Technical News 162
March 2015
Strictly Confidential

Contents		
Item	Subject	Model Affected
Item 1.	Rear Pulley Carrier Needle Roller Bearing	Thunderbird ABS, Thunderbird Commander, Thunderbird LT and Thunderbird Storm

Description: Rear Pulley Carrier Needle Roller Bearing

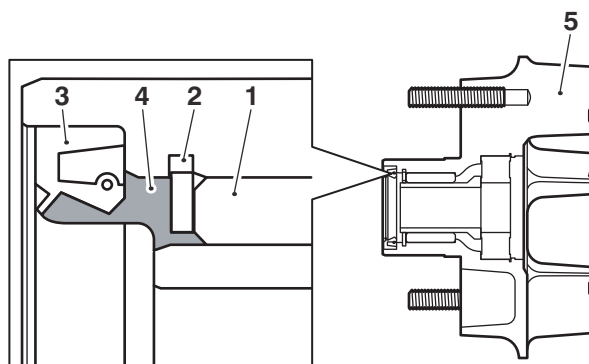
Additional grease to NLGI 2 specification (Triumph recommends Castrol Grease) has been added to fill the gap between the seal and the needle roller bearing within the rear pulley carrier on the above models from VIN 667870.

When the rear wheel spindle has been removed for whatever reason, check and, if necessary, add grease to fill the gap between the seal and the needle roller bearing, as shown in the illustration below.

Description: Drive Chain Guard, Drive Chain Rubbing Strip and Lower Yoke Pinch Bolts

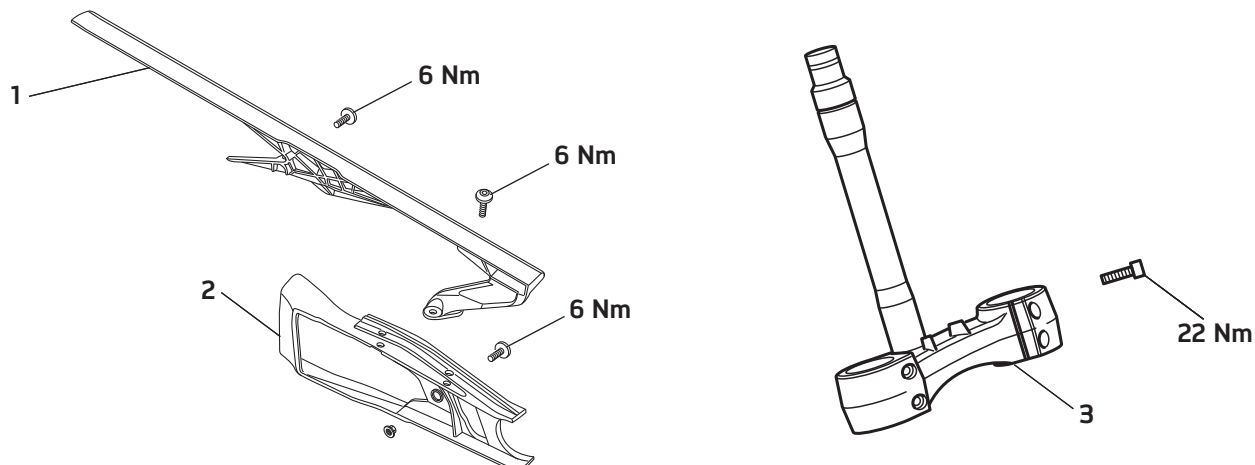
The torque figure for the lower yoke pinch bolts has changed to **22 Nm** on the above models. The torque figures for the drive chain guard screws and the drive chain rubbing strip have also changed to **6 Nm**.

- **Models already in service need not be retightened unless the fixings have been loosened or removed.**

Description: Horn Fixing

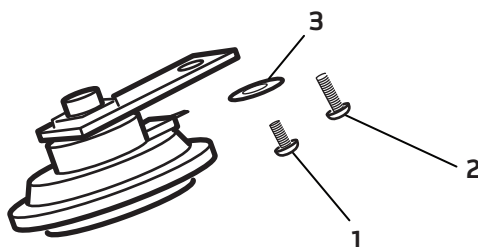
New encapsulated fixings and a washer have been introduced to secure the horn on the above models at various VINs. Different fixings are required for the Thunderbird Commander and Thunderbird LT, as described below.

The encapsulated fixing M6 x 20 mm (part number T3205085) and a washer (part number T3554200) was introduced at VIN 685177.

The encapsulated fixing M6 x 28 mm (part number T3205081) and a washer (part number T3554200) was introduced at VIN 684982.

The torque figure for both fixings is **9 Nm**.

- Models already in service need not be retightened unless the fixings have been loosened or removed.
- If loosened or removed for any reason the fixings must be replaced and a washer fitted.

Description: Clutch Cable

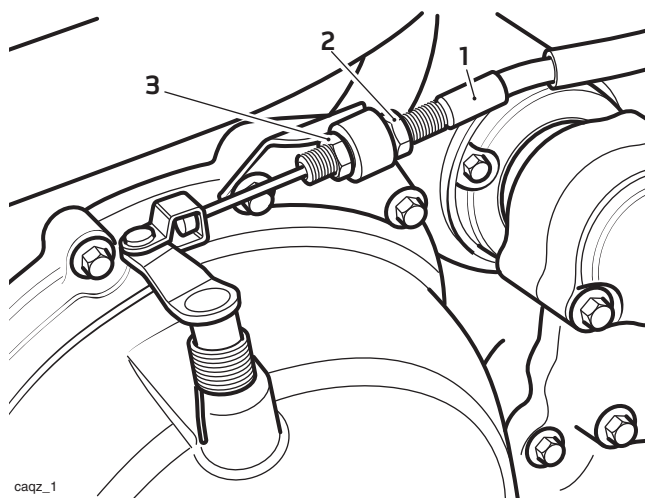
A torque figure for the clutch cable adjuster nut, at the clutch end, has been introduced on the above models.

The adjustment of the clutch cable is as described in the Service Manual with the addition of tightening the adjuster nut to **3 Nm**.

Description: Instrument Assembly

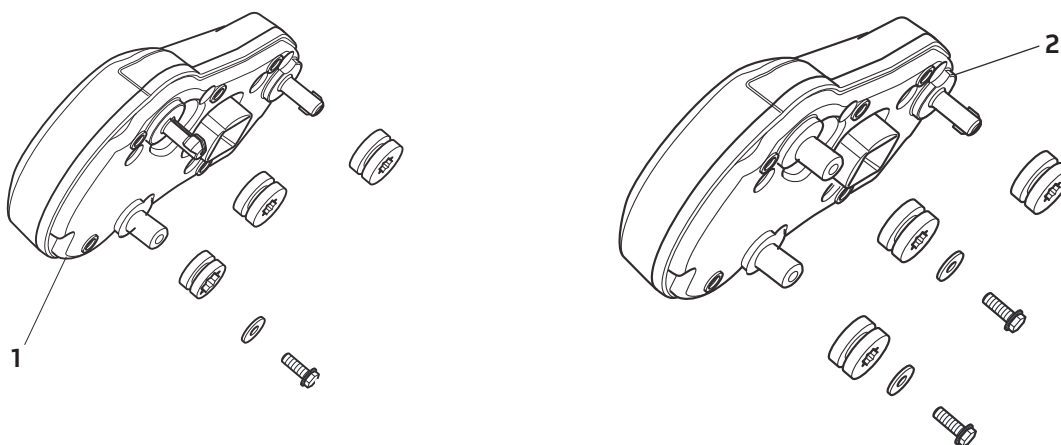
Revised instrument assemblies have been introduced to the above models at various VINs.

The difference between the original and latest versions of the instrument assemblies is the mounting of the instrument assembly to the motorcycle. The latest version has an extra fixing and washer to secure the instrument assembly to its mounting, as shown in the illustration below.

Parts will no longer support the original condition instrument assemblies, replacement instrument assemblies will be to the new condition.

For models built before the instrument assembly change, parts kits are available if the instrument assembly requires replacing. Refer to the parts table for the relevant part number.

Item 8.**Description:** Instrument Nacelle**Models affected:** Rocket III Touring, Rocket III Touring SE and Rocket III Touring ABS

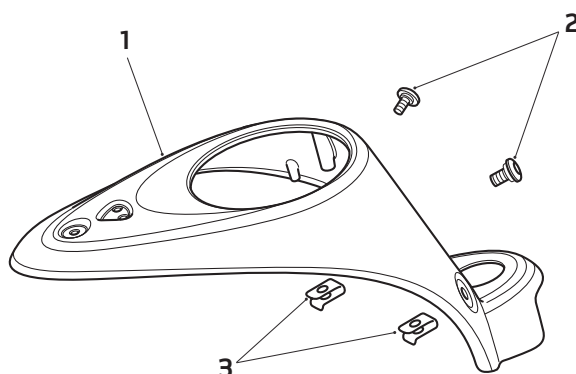
A new instrument nacelle and its two front fixings have been introduced to the above models from VIN 679547.

The difference between the original and new instrument nacelle is that the two front fixing holes diameter has increased to 12 mm.

The two front fixings have changed to a shouldered bolt and the captive nuts have also changed.

The torque figure for the front two fixings has changed to **5 Nm**.

The torque figure for the rear fixing remains at **7 Nm**.

For models built from VIN 679547 the items can be replaced like for like.

For models built up to VIN 679546 a parts kit (part number T2501464) is available when replacing the instrument nacelle. The parts kit consists of the following items listed in table below.

Description: Final Drive Chain and Sprockets

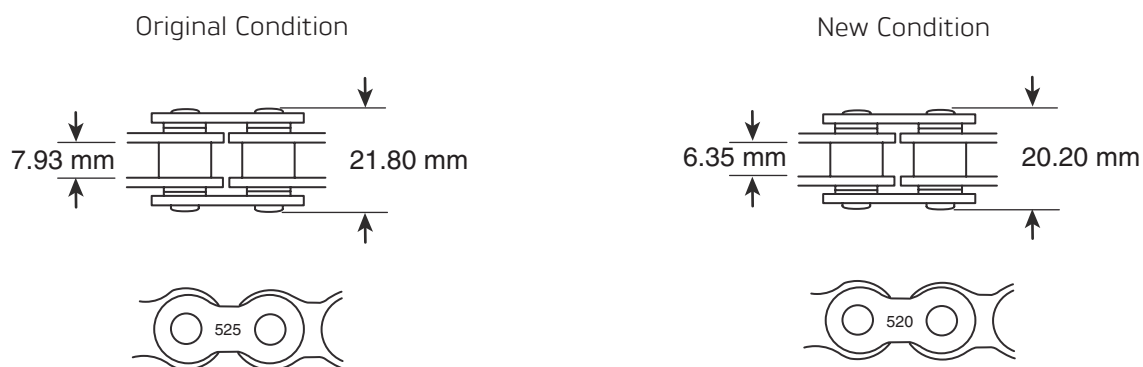
New sprockets and final drive chain have been introduced to the above models from the following VINs which are not retrofittable:

The difference between the original condition and new condition drive chain is the width of the chain.

The original condition drive chain can be identified with the number 525 etched on to some of the outer and/or inner plates of the links.

The new condition drive chain can be identified with the number 520 etched on to the links.

The thickness of the sprockets has also been reduced to suit the width of the new final drive chain.

Triumph recommends that when replacing the final drive chain, the front and rear sprockets should also be replaced. To facilitate this the following spares kits are available.

If the final drive chain or sprockets are found to be worn, always replace the sprockets and final drive chain together.

Description: Rear Mudguard Fixings

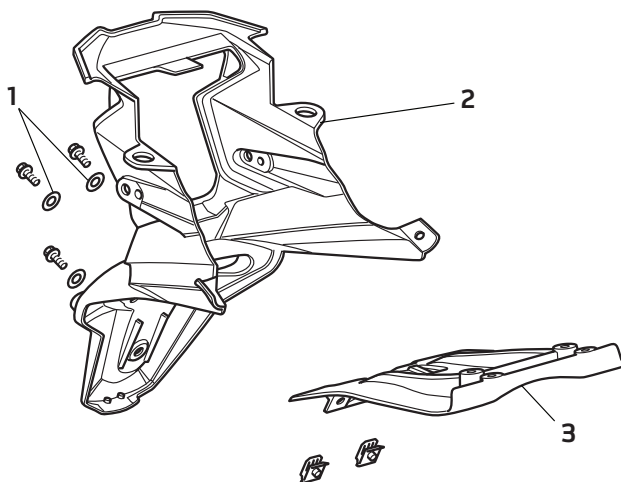
Washers have been introduced to the fixings securing the licence plate hanger to the under tray moulding on the above models from VIN 688563.

The torque figure for both fixings is **3 Nm**.

Description: Lubrication Main Gallery Threaded Insert

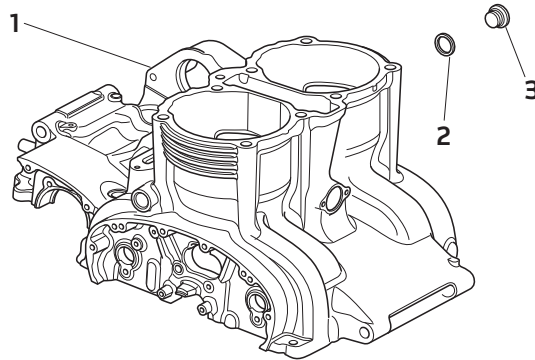
The torque figure for the lubrication main gallery threaded insert on the left hand side of the crankcase has changed to **60 Nm** on the above models.

As a reminder, always install a new copper washer if the threaded insert has been loosened or removed.

Description: Coolant Expansion Tank
Models affected: Tiger Explorer and Tiger Explorer XC

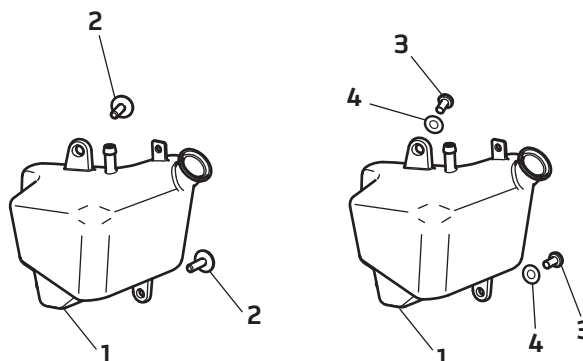
New fixings and washers have been introduced for the coolant expansion tank on the above models from VIN 700222. The new fixings have a smaller size head and a washer must also be fitted with these fixings. The torque figure for these fixings remains at **9 Nm**.

Description: Piston Rings
Models affected: Thunderbird 1700 cc Models

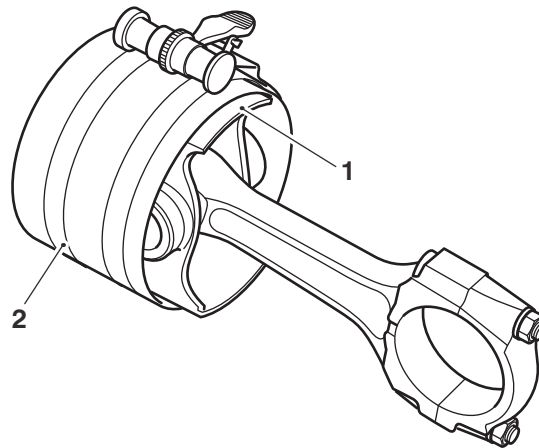
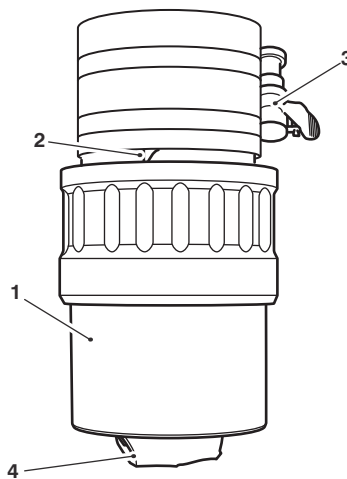
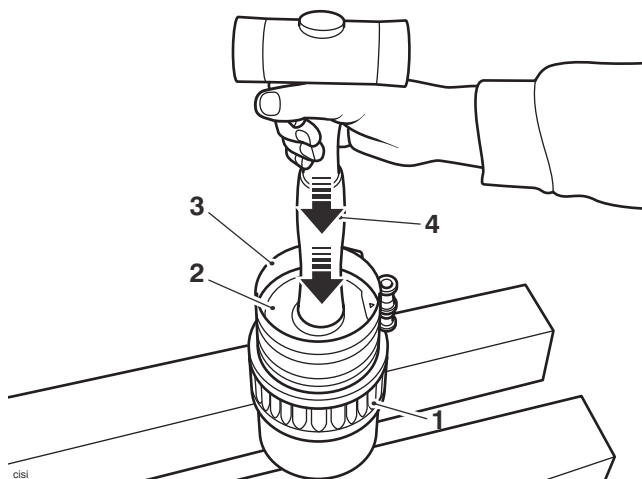
A revised method of installing the piston to the liner has been introduced on the above models and will be included in the next Service Manual update.

1. Place the liner on a level surface and smear the internal circumference with clean engine oil.
2. If previously removed refit the connecting rod to the piston as described in the Service Manual.
3. Lubricate the piston rings and fit them to the piston as described in the Service Manual.
4. Smear the piston with engine oil.

-
- Using a suitable automotive piston ring compressor, compress the piston rings ensuring the piston rings locate into their piston grooves.

- Ensure the connecting rod and big end are protected with a protective covering (e.g. masking tape) before placing the big end into the liner.
- Align the piston skirt to the top edge of the liner.

7. Whilst supporting the liner and piston ring compressor, gently tap the piston into the liner until it becomes free from the piston ring compressor.

Do not use excessive amounts of force when installing the piston into the liner. Excessive force may cause the piston to fracture or the piston rings to become dislodged causing severe engine damage.
